**Stormwater Addendum #1
For
Definitive Subdivision Plan for Colton Road Extension
Millbury, Massachusetts**

Prepared by:
Atlantic Design Engineers, Inc.
P.O. Box 1051
Sandwich, Massachusetts 02563

August 27, 2020
Atlantic Project No. 3085.00

This Addendum #1 to the original Stormwater Report dated 5/10/2020 for the proposed Colton Road Extension has been prepared to address plan revisions resulting from comments received during municipal/peer review. The extension will now include an additional 4" of pavement millings on 8" of gravel subbase per the revised plans (revision 2 dated August 27, 2020). Based on this change a modification to the curve number has now been conservatively assumed to increase to 98. Subsequently, additional improvements to the stormwater now include an infiltration area.

POST-DEVELOPMENT WATERSHED PLAN
FOR
DEFINITIVE SUBDIVISION PLAN FOR COLTON ROAD EXT.
MILLBURY, MASSACHUSETTS 01527
JUNE 10, 2020

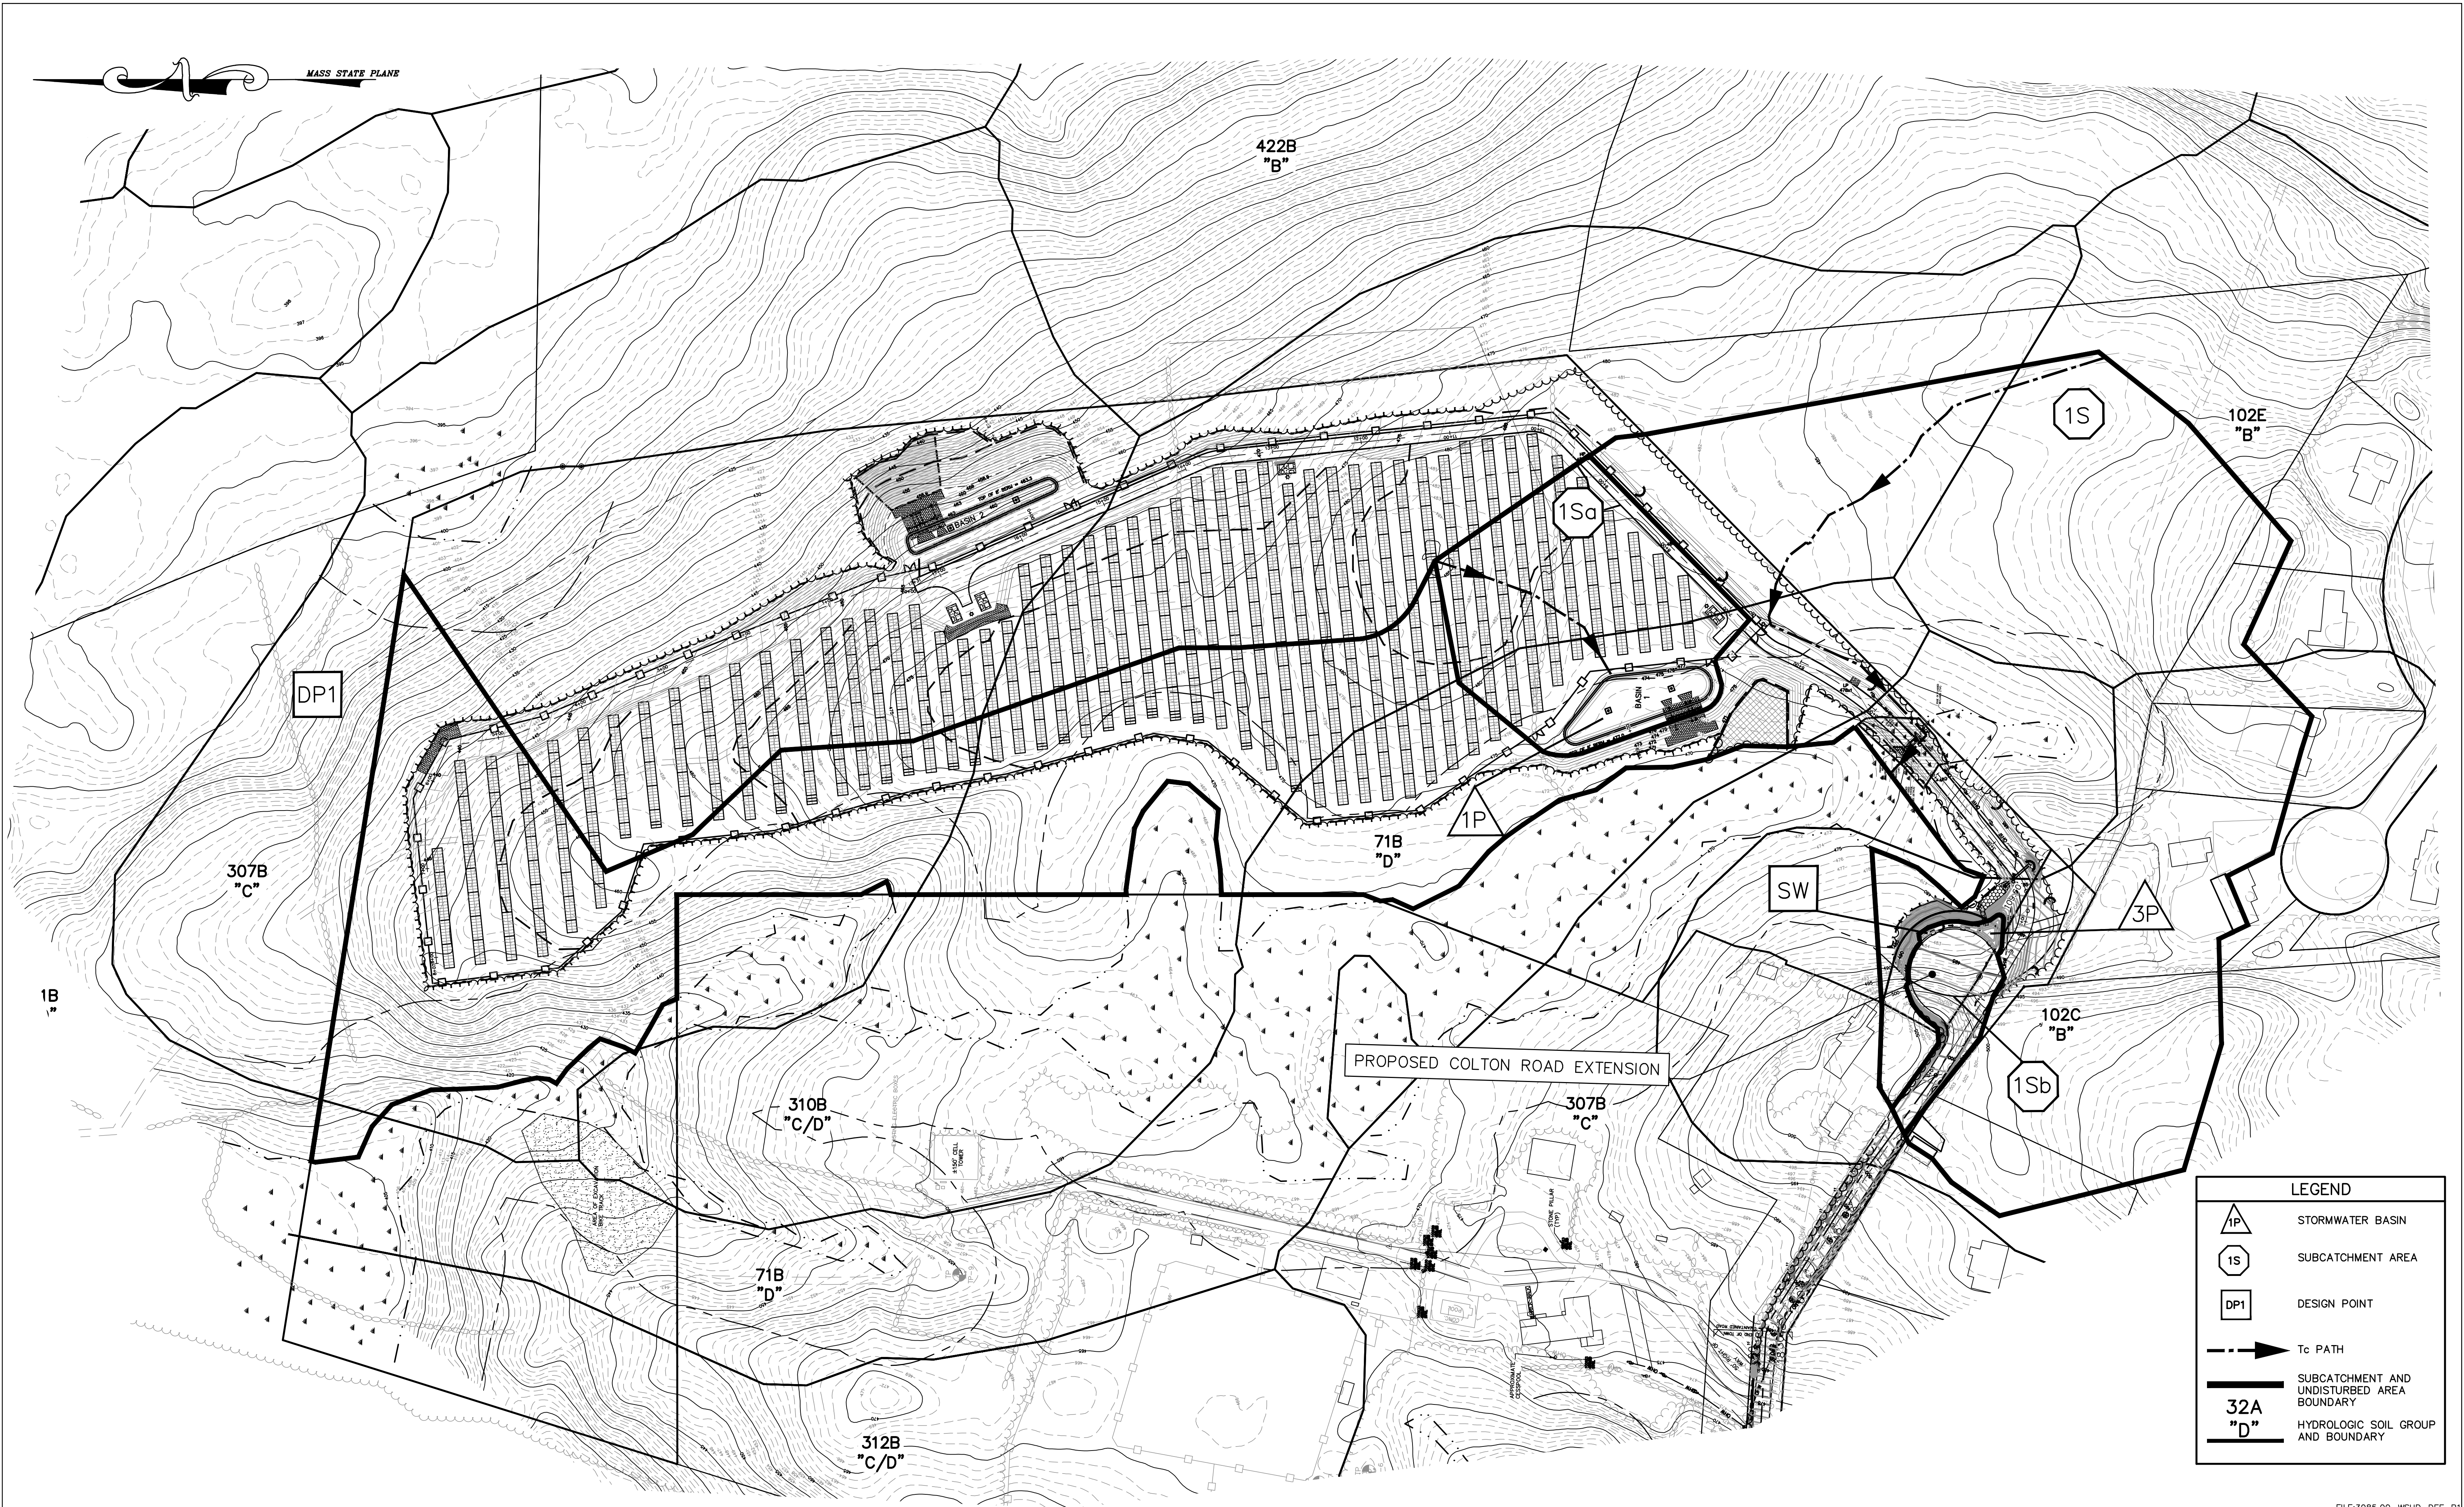
- Updated MASS DEP Checklist for Stormwater Report – Revision 1
- Updated Post-Development HydroCAD stormwater analysis with modeling of the Infiltration Area and Swale.
- Revised Post-Development Watershed plan
- Revised Long term Operation and Maintenance plan with Inspection Log – Revision 2
- Changes included in the Revised Definitive subdivision plans for Colton Road Extension Plans Dated August 27, 2020
- Supplemental calculations Water quality, Recharge and TSS.

NO.	BY	DATE	REVISION
1	PMJ	8-27-20	REVISED PER TOWN COMMENTS
